Bulletin No: Issued: **L048** 101230

## 3 MT Fixed Cap Unihook Hex Bolt and Locking Tab Conversion Kit – PA8181:

#### This Kit pertains only to Model 26A049, 26A062, 26A090 and 26A093 UNIHOOK™

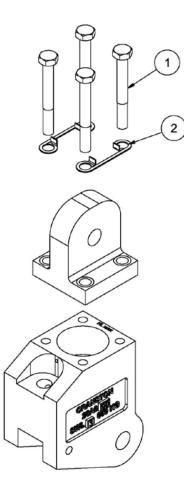
### WARNING! – ONLY USE THE M30600006 BOLTS. THEY ARE SPECIAL HIGH STRENGTH BOLTS. DO NOT SUBSTITUTE ANY OTHER HEX HEAD BOLTS.

- 1. Cut and remove the existing lock wires on the existing socket head cap screws.
- 2. Remove the existing socket head cap screws.
- Install Item 2 on each side of top cap with Item 1 bolts.
- 4. Torque bolts, Item 1, to 24-29 ft-lbs Make sure a flat on each bolt is aligned with a lock tab of Item 2 and bend up against bolt head.
